Sundry Print Report

Well Name: JAMES RANCH UNIT Well

Notice of Intent

Type of Action: Plug and Abandonment

JRU 109H - Proposed WBD

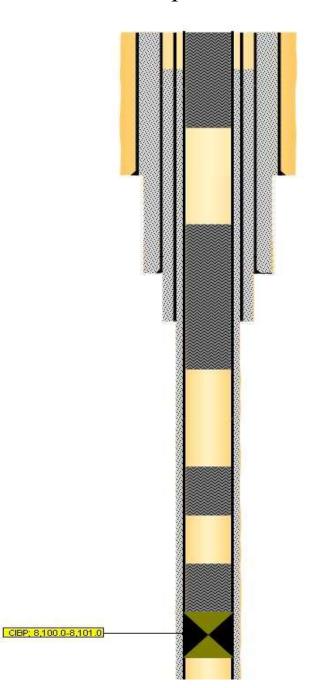
Sundry ID	2746774						
						Cement	
Plug Type	Тор	Bottom	Length	Tag	Sacks	Class	Notes
Surface Plug	0.00			Tag/Verify	Guono	Olubb	Notes
Fresh Water @ 350	296.50	400.00	103.50				
Top of Salt @ 624	567.76			Tag/Verify			
Shoe Plug	589.54			Tag/Verify			
Base of Salt @ 3648	3561.52			Tag/Verify			
Delaware @ 3918	3828.82	3968.00	139.18				
Delaware @ 3916	3020.02	3900.00	139.10	ii soliu			Spot cement from
Shoe Plug	3847.63	3987.00	139.37	Tag/Verify	650.00	С	3987' to surface.
Spacer Plug @ 5000	4900.00	5050.00	150.00	If solid base no need to Tag (CIBP present and/or Mechanic al Integrity Test), If Perf & Sqz then Tag, Leak Test all CIBP if no Open Perforations	25.00	С	Spot cement from 5050' to 4900'.
Bonesprings @ 7682	7555.18	7732.00	176.82	If solid base no need to Tag (CIBP present and/or Mechanic al Integrity Test), If Perf & Sqz then Tag, Leak Test all CIBP if no Open Perforatio ns	36.00	Н	Spot cement from 7732' to 7555'.

If solid base no need to Tag (CIBP present and/or Mechanic al Integrity Test), If Perf & Sqz then Tag, Leak Test all CIBP if no Open			Set CIBP at 8100'.
				Perforatio			Spot 30 sxs on top.
CIBP Plug	8065.00	8100.00	35.00		30.00	Н	Leak test CIBP.
Shoe Plug	8099.68	8282.00		Tag/Verify			
Perforations Plug (If No CIBP)	8250.00	14097.00		Tag/Verify			
Shoe Plug	13909.00	14150.00	241.00	Tag/Verify

No more than 2000' is to be allowed between plugs in open hole, and no more than 3000' between plugs in cased hole.
